**From:** Beaulieu, Jacquelyn Marie <jacquelyn.beaulieu@gapac.com>  
**Sent:** Monday, June 5, 2023 11:41 AM  
**To:** Lauridsen, Keld B - DNR  
**Cc:** Savale, Michael; Schultz, Josie M - DNR; Bonniwell, Chris; Mrotek, Melissa A  
**Subject:** RE: GP Broadway Mill Expansion - PFAS (BRRTS # 02-05-586429)  
**Attachments:** Figure 1\_Site Details\_05-31-23.pdf

Please see below for GP's responses to the requested follow up the facility received from the WDNR regarding the Groundwater Evaluation Summary Report GP submitted to the department on March 28, 2023.

DNR has reviewed the *Groundwater Evaluation Summary Report* received on March 28, 2023, and provides the following comments:

GEORGIA-PACIFIC BROADWAY MILL  
 GREEN BAY, WISCONSIN

**SITE DETAILS**

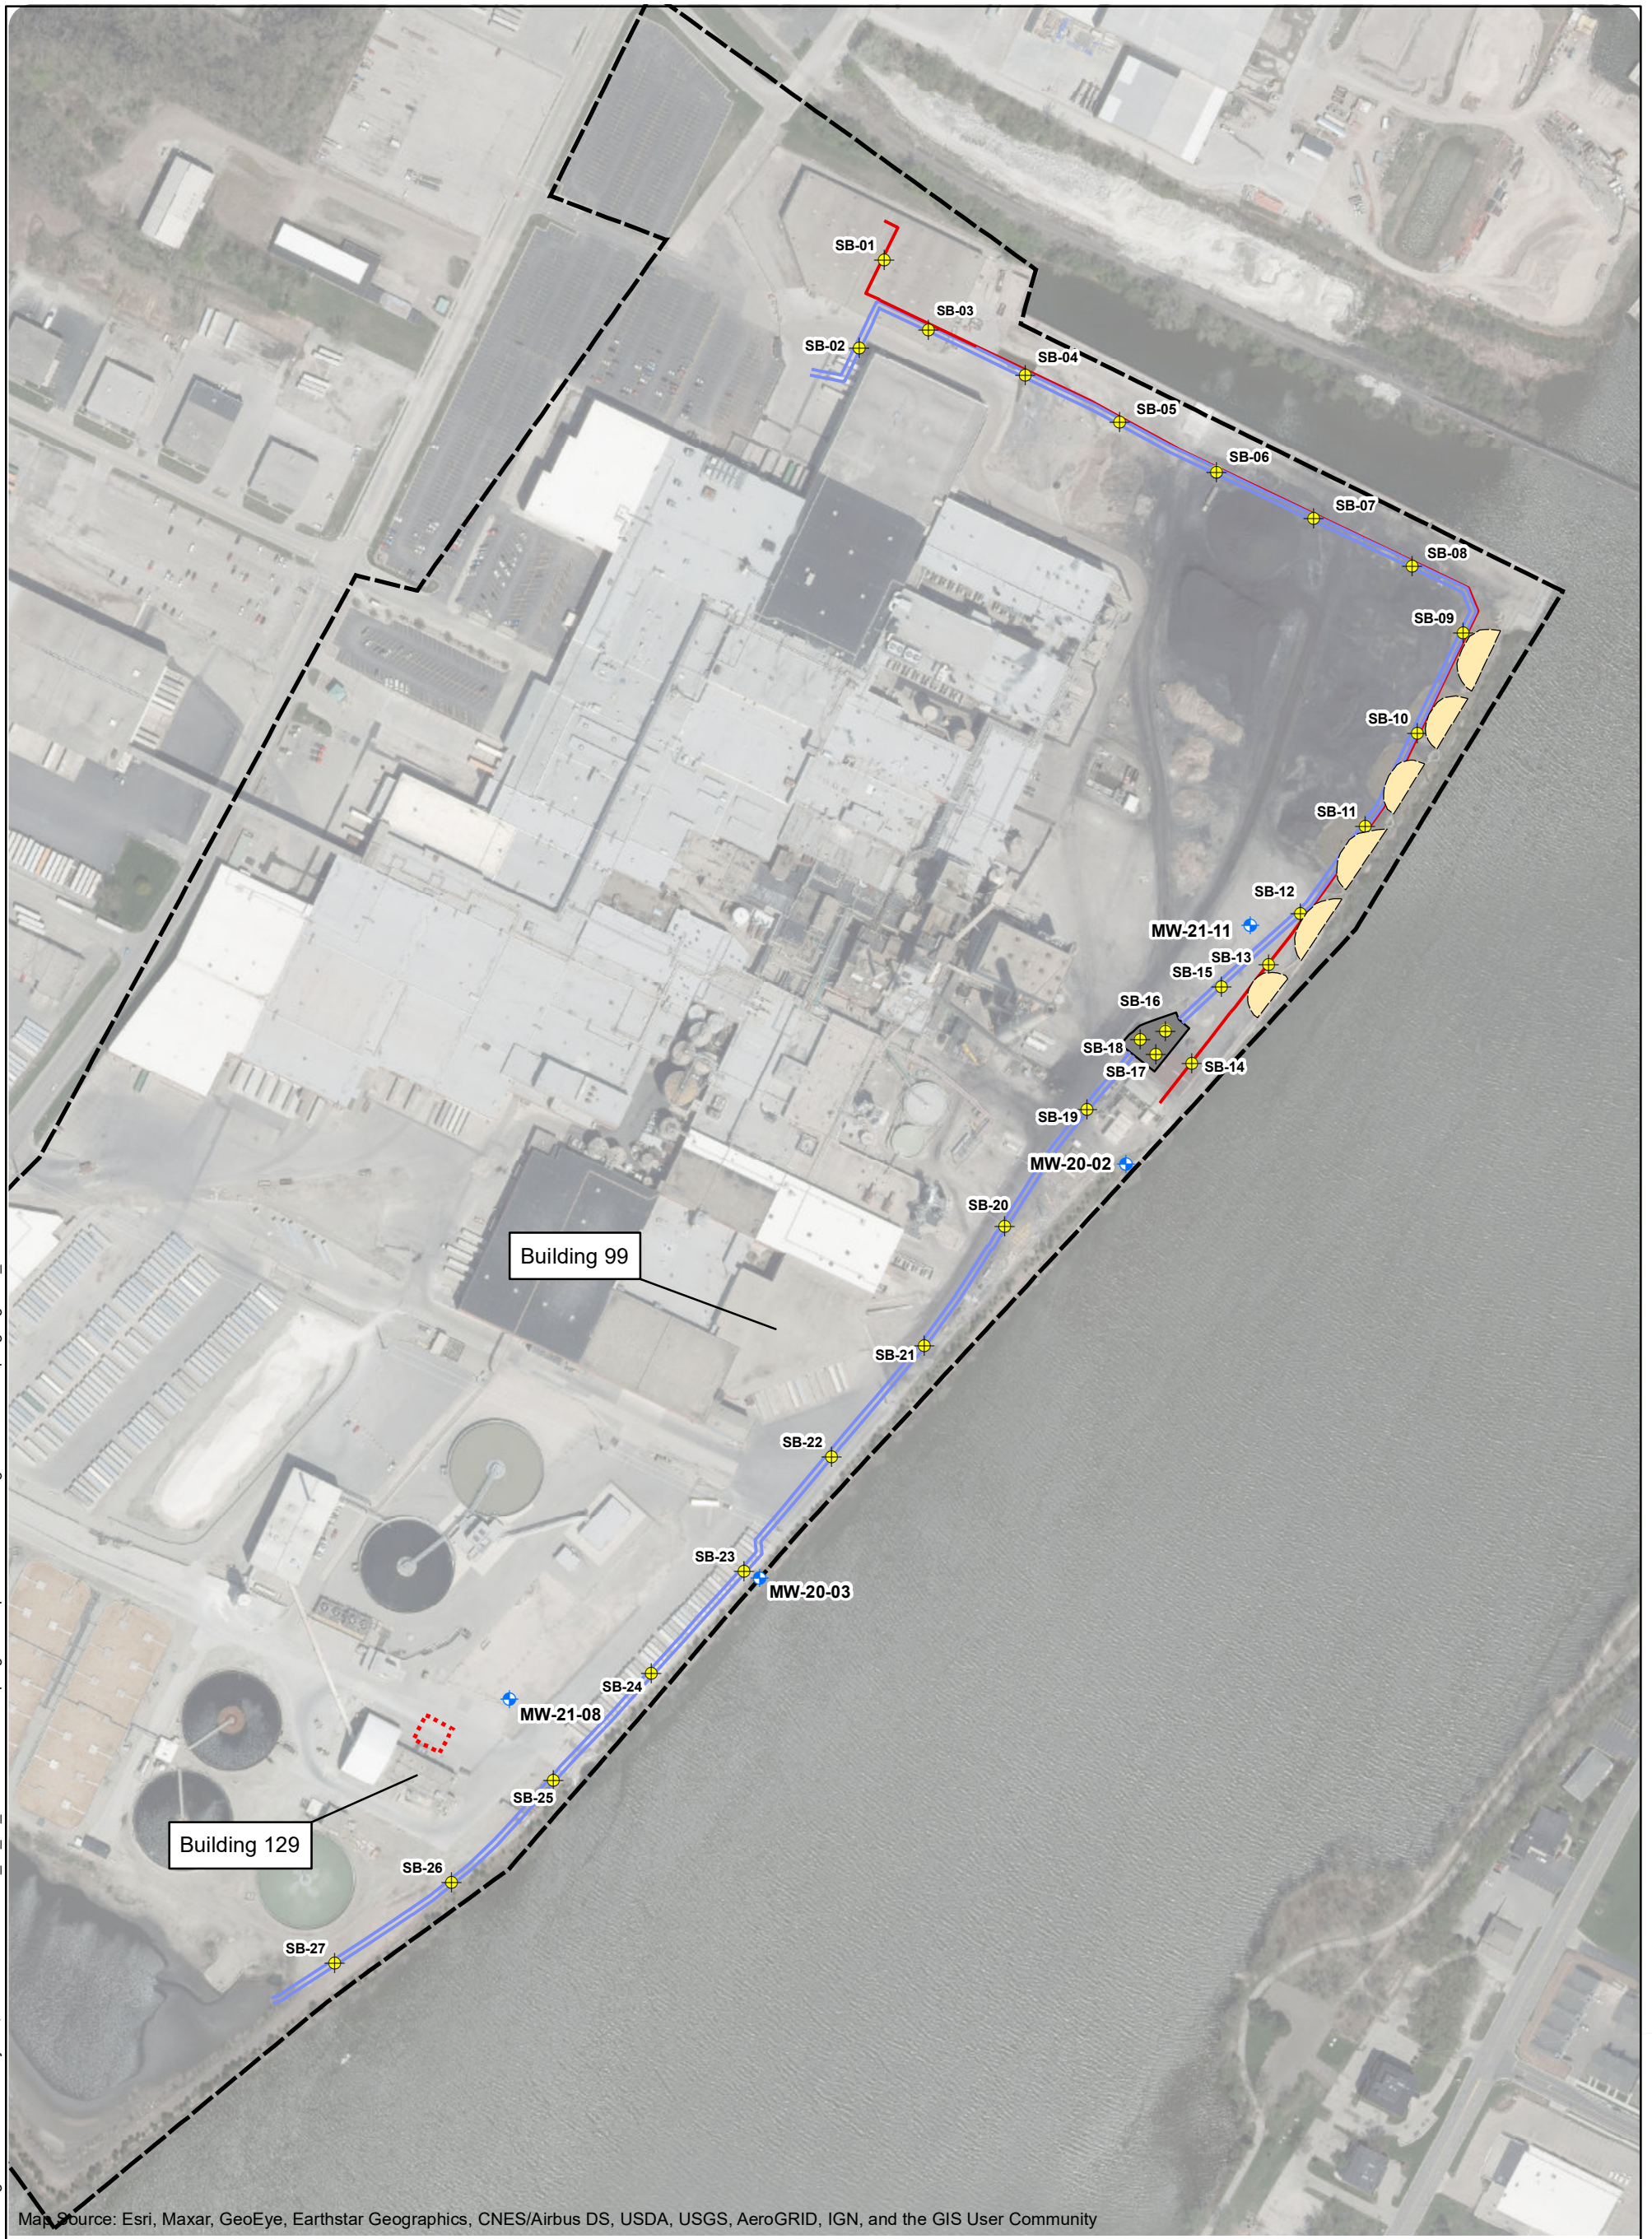
Correction – The previously submitted documents incorrectly identified Building 125, which should have been noted as Building 129.

WDNR identified that Building 99 potentially screens in for VI due to its proximity to soil boring SB-21, which contained low-level concentrations of tetrachloroethene (PCE) [0.0785 mg/kg]; 1,1,1-trichloroethane (1,1,1-TCA) [0.1402 mg/kg]; 1,1-dichloroethane (1,1-DCA) [0.4834 mg/kg]; and methylene chloride [0.0026 mg/kg]. However, a review of the soil investigative records shows the GPS location of SB-21 (N44°29'25.62266", W88°01'55.30203") to be greater than 100 ft from the nearest (southeast) corner of Building 99 (108 ft). Per RR 800, structures within 100 ft. of chlorinated volatile organic compound (CVOC) soils impacts are required to be evaluated.

The building potentially screens in for VI due to its proximity to the adjacent sludge press area excavation. Analytical results from spoil pile samples SP-01 through SP-12 originating from that excavation identified low-level concentrations of CVOCs including 1,1,1-trichloroethane (1,1,1-TCA) [max 0.105 mg/kg]; 1,1-dichloroethane (1,1-DCA) [max 0.131 mg/kg]; PCE [max 0.0596 mg/kg]; trichloroethene (TCE) [max 0.0535 mg/kg]; and methylene chloride [max 0.0026 mg/kg]. While these soils originated within the 100 ft screening criteria of RR-800 from Building 129, the soils were excavated and removed from the area.

*Residual metal, PAH and PCB contamination in soil will likely be delineated as property-wide or within portions of the property having contaminated historic soil fill present. It may be possible to delineate areas of VOCs in soil as this type of contaminant is less likely to be present property-wide. Any available soil data from other contamination cases on the property may potentially be used to better delineate residual contamination.*

Report. On-site re-use of soils associated with BRRTS #02-05-563707 along the northeast perimeter are coincident with several soil boring locations. Based on the low-level concentrations of VOCs identified in soil borings, the re-use of impacted soils on the property, the industrial nature of the property area in question, and no detectable VOC concentrations in groundwater, Tetra Tech believes that no additional delineation of VOCs is warranted.

*Provide further explanation of the purpose and construction of the “wet well” referenced in the report.*

- Based on the available soil sampling results, it appears that buildings 99 and 125, at a minimum, may be at risk for vapor intrusion based on the screening guidelines in DNR guidance document RR-800, *Addressing Vapor Intrusion at Remediation & Redevelopment Sites in Wisconsin*. Please provide additional information on building use and occupancy, any air exchange and any utility lines leading to the buildings from the areas of know VOC contamination.

Based upon the low-level soil concentrations at SB-21, its location greater than 100 ft from the structure, the high ceiling industrial operation, lack of contained operating spaces (e.g., offices), and lack of preferential pathways connecting to the building, Tetra Tech considers the building to be unlikely at risk for VI.

Based upon the low-level soil concentrations from excavation soil samples, the subsequent removal of excavated soils, lack of continuous occupancy, continuous state of positive pressure (which minimizes the potential for sub-slab vapor to migrate upward into the building), and lack of preferential pathways connecting the excavation area to the building, Tetra Tech considers the building to be unlikely at risk for VI.

The “wet well” terminology refers to an engineering structure that will serve as a stormwater retention basin and lift station. The structure is concrete lined, and engineering drawings of the structure are available for further clarification if needed.
